Platt Technical High School

ADDENDUM NO. 4

August 9, 2019

100% CONSTRUCTION DOCUMENTS				STATE OF CONNECTICUT DEPARTMENT OF ADMINISTRATIVE SERVICES	
drawing title		INTERIOR ELEVATIONS		drawing prepared by	
drawing title		INTERIOR ELEVATIONS		DRA ARCHITECTS

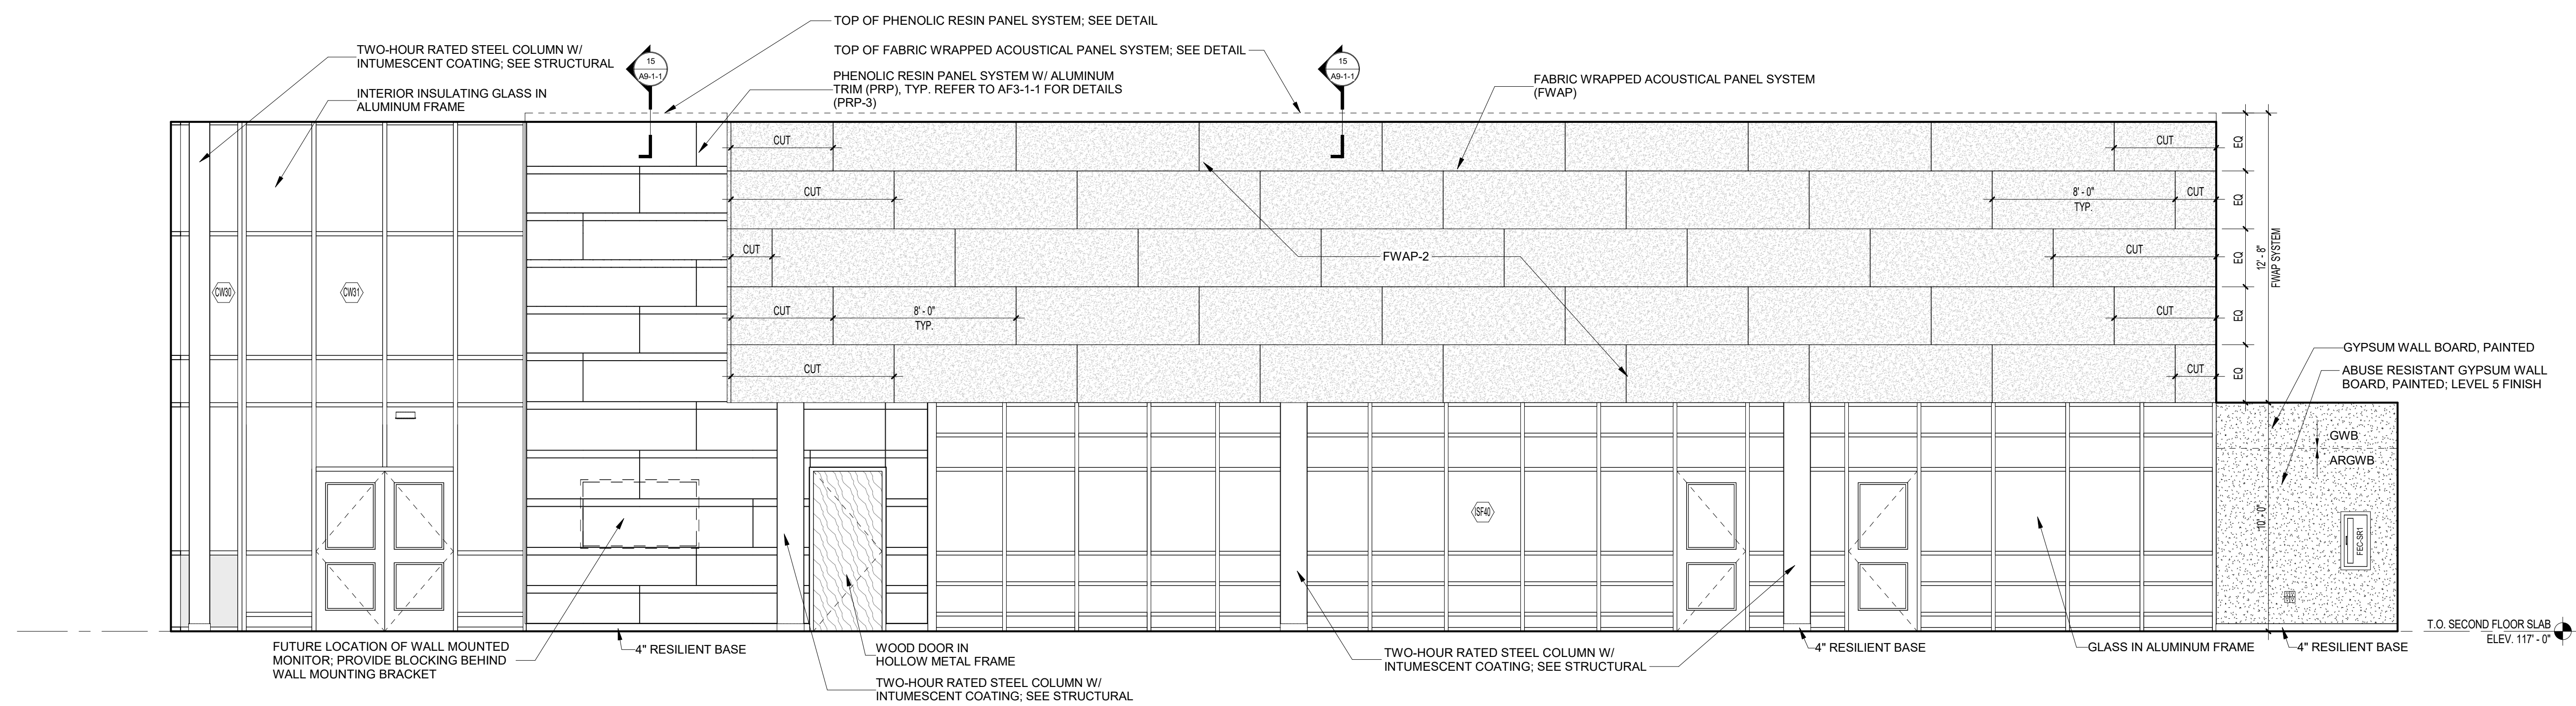
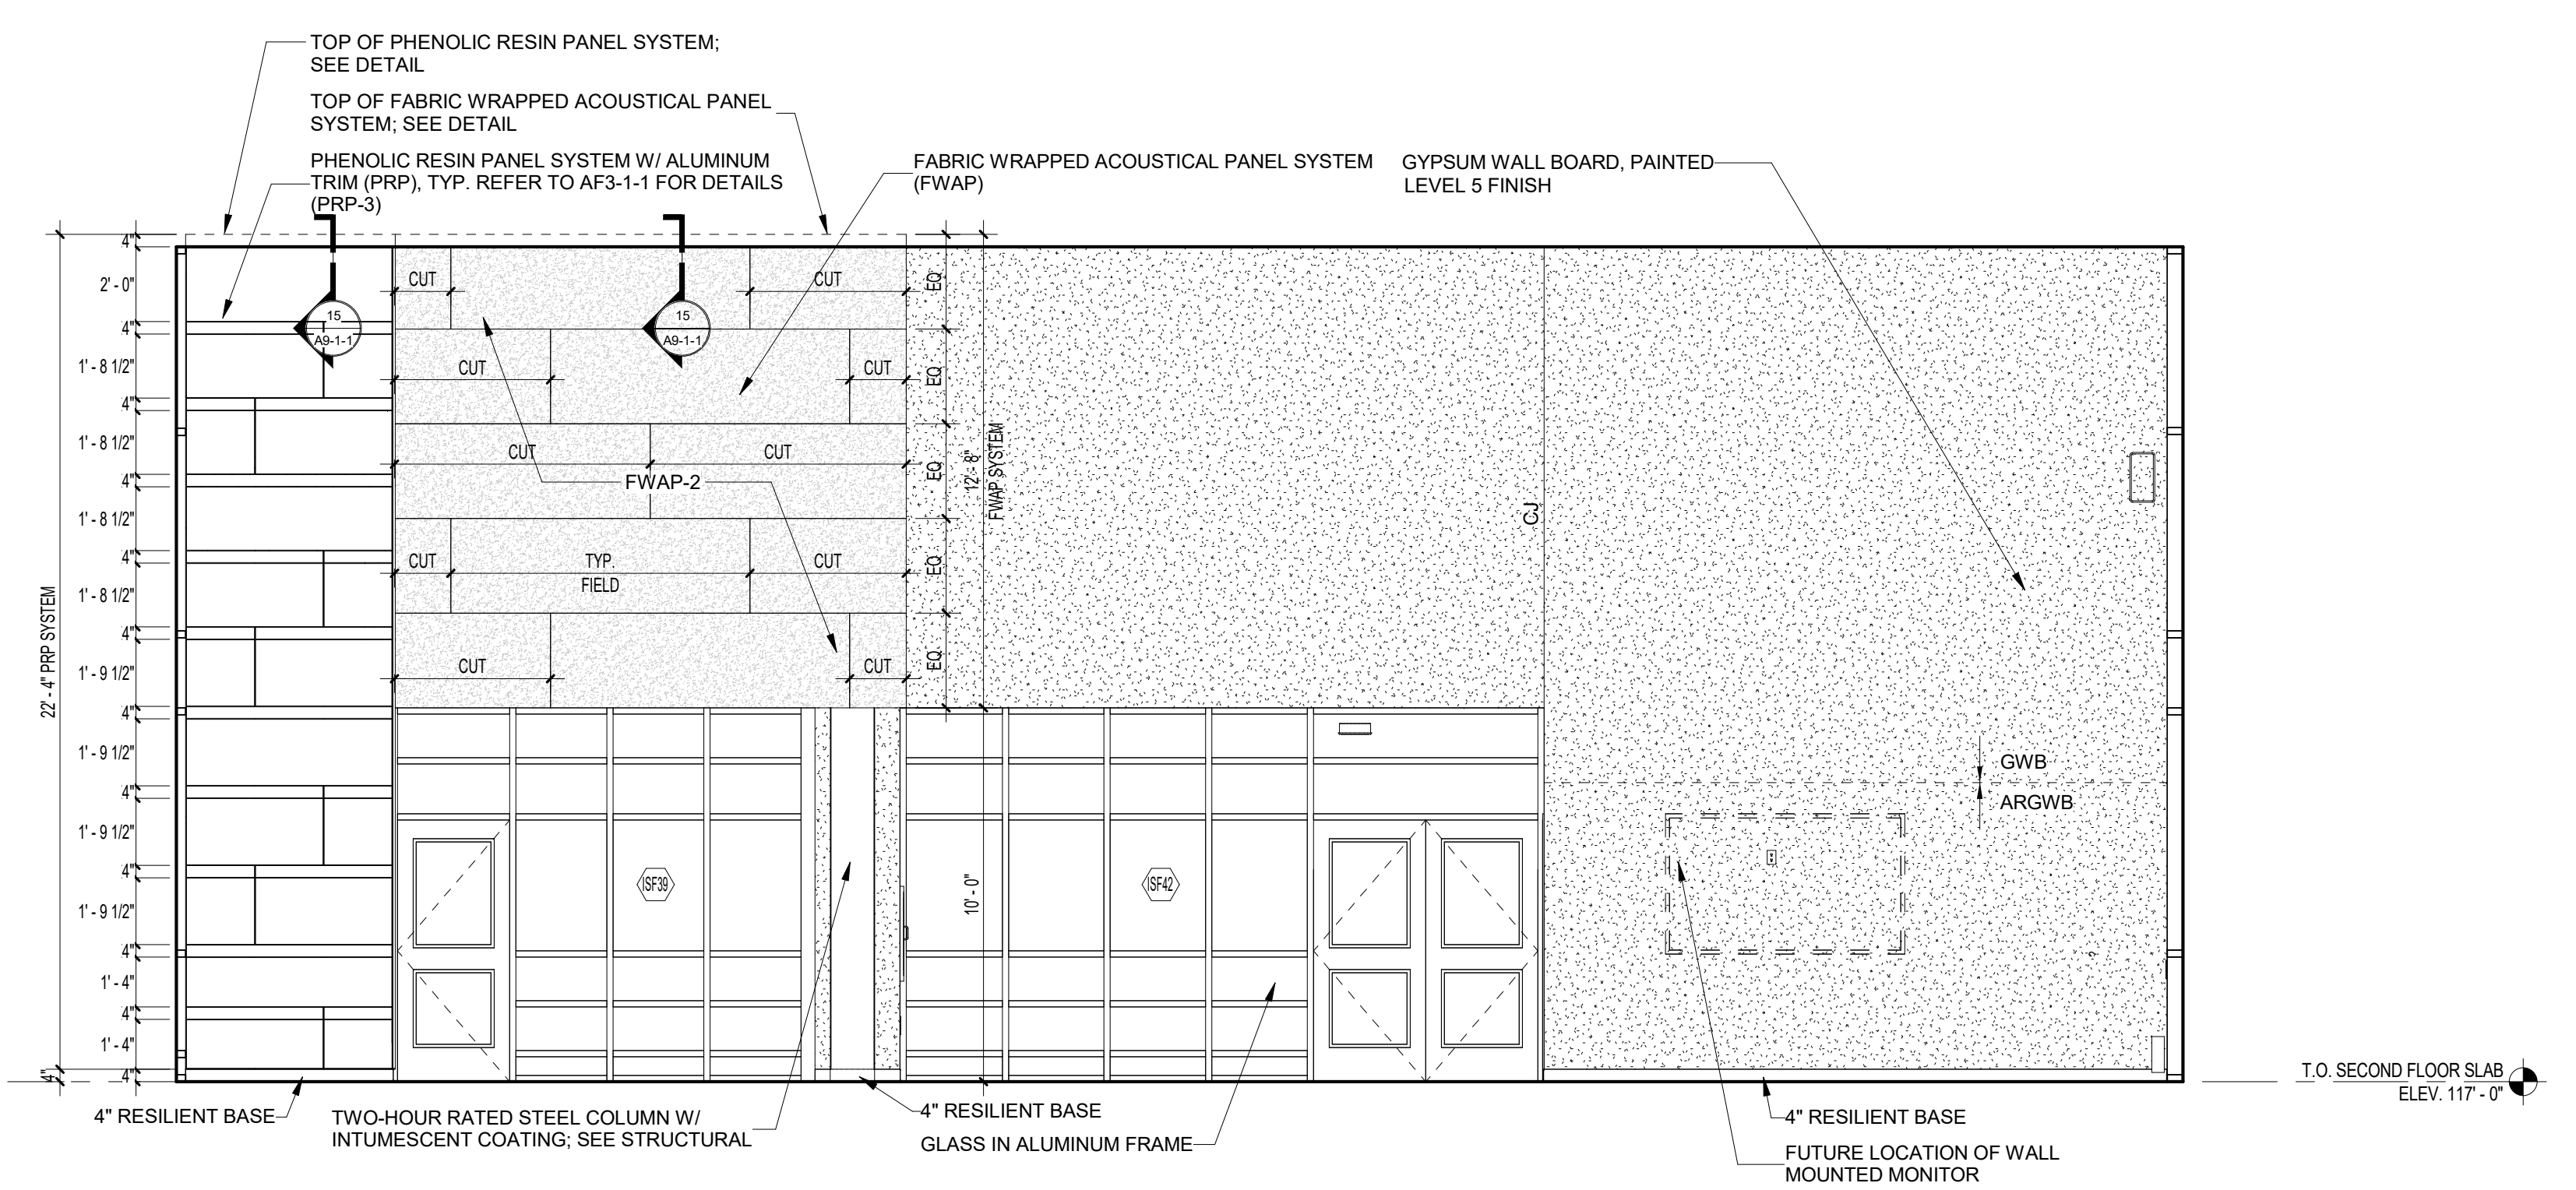
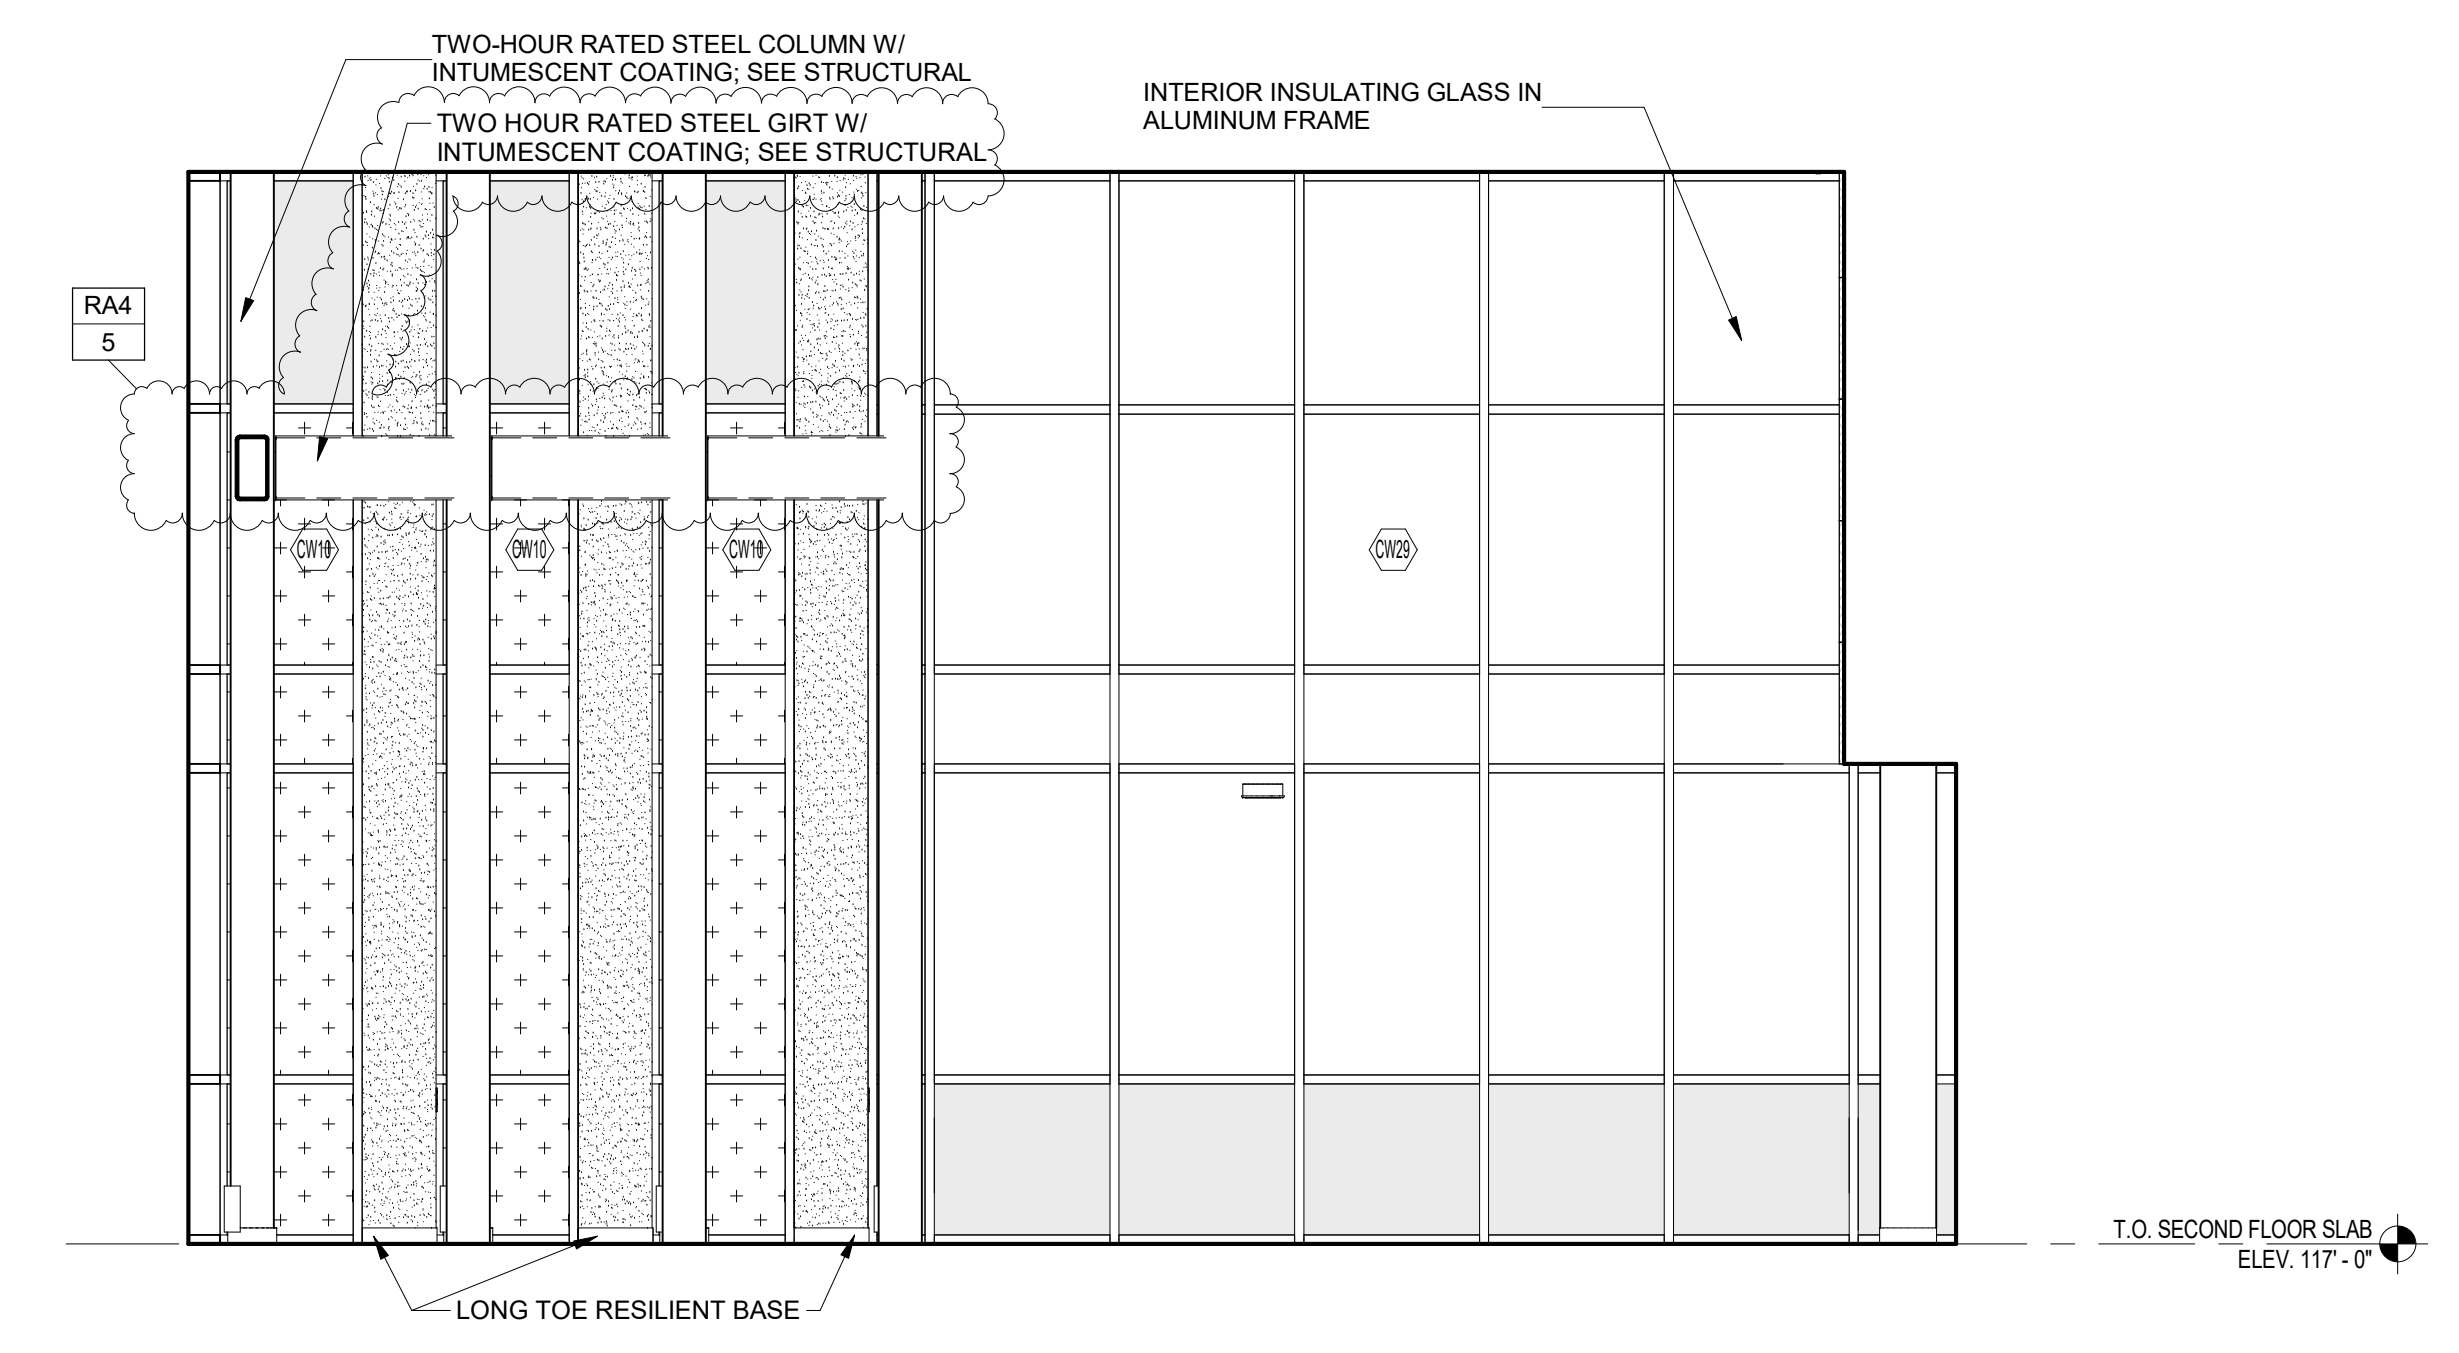
- ADD 4-071** **A2-2-1 – INTERIOR ELEVATIONS**
Interior Elevation 5: Revised Aluminum Frame Tags per Revision Sketch RA4-04.
- ADD 4-072** **A2-2-3 – INTERIOR ELEVATIONS**
Interior Elevation 1 and 2: ADDED Structural Steel Girt, with intumescent coating, per Revision Tag RA4-5
